Access Compliance Report

Public Rights-of-Way

Intersection ID: 49147	Main Street: SAINTE_ROSE_LN	Cross Street: OLD_PROVIDENCE_LN	Location: SE
ADA ID: BC5AA4CD6BA6	Ramp Type: PerpDiag	Initial Pass/Fail: Fail	Overall Compliance: No
		Severity Score: 50

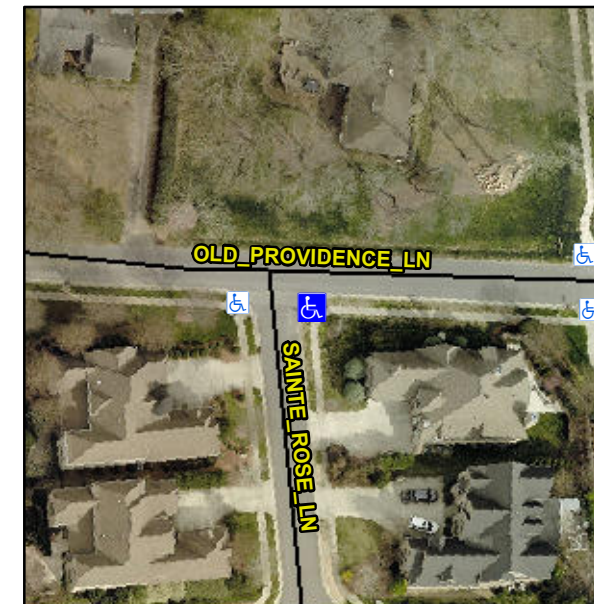
Not Found, R304.2.2, R304.5.3

Compliance	Description	Data	Compliance	Description	Data
N/A	Ramp Length (in)	48.0	No	Ramp Slope (%)	12.4
Yes	Ramp Width (in)	48.0	No	Ramp XSlope (%)	8.1
N/A	Flare Type LT	N/A	N/A	Flare Type RT	N/A
N/A	Flare Slope LT (%)	N/A	N/A	Flare Slope RT (%)	N/A
N/A	Flare Traversable LT?	N/A	N/A	Flare Traversable RT?	N/A
N/A	Landing Length (in)	N/A	N/A	DWS Provided?	N/A
N/A	Landing Width (in)	N/A	N/A	DWS Contrast?	N/A
N/A	Landing Slope (%)	N/A	N/A	DWS Length (in)	N/A
N/A	Landing X Slope (%)	N/A	N/A	DWS Full Width?	N/A
N/A	Landing Curb? (Y/N)	N/A	N/A	DWS Offset (in)	N/A
N/A	Shared Landing?	N/A			
N/A	Gutter Ponding?	N/A	N/A	Gutter Slope (%)	N/A
N/A	Gutter Lip Ht (in)	N/A	N/A	Gutter X Slope (%)	N/A
N/A	Painted X Walk1?	No	N/A	Painted X Walk2?	No
	X Walk 1 Direction	To N		X Walk 2 Direction	To NW
N/A	X Walk 1 Width (in)	N/A	N/A	X Walk 2 Width (in)	N/A
	X Walk 1 Slope (%)	7.1		X Walk 2 Slope (%)	3.2
	X Walk 1 X Slope (%)	3.0		X Walk 2 X Slope (%)	5.5

Remove & Replace Curb Ramp With Two New Directional Ramps or Equivalent.
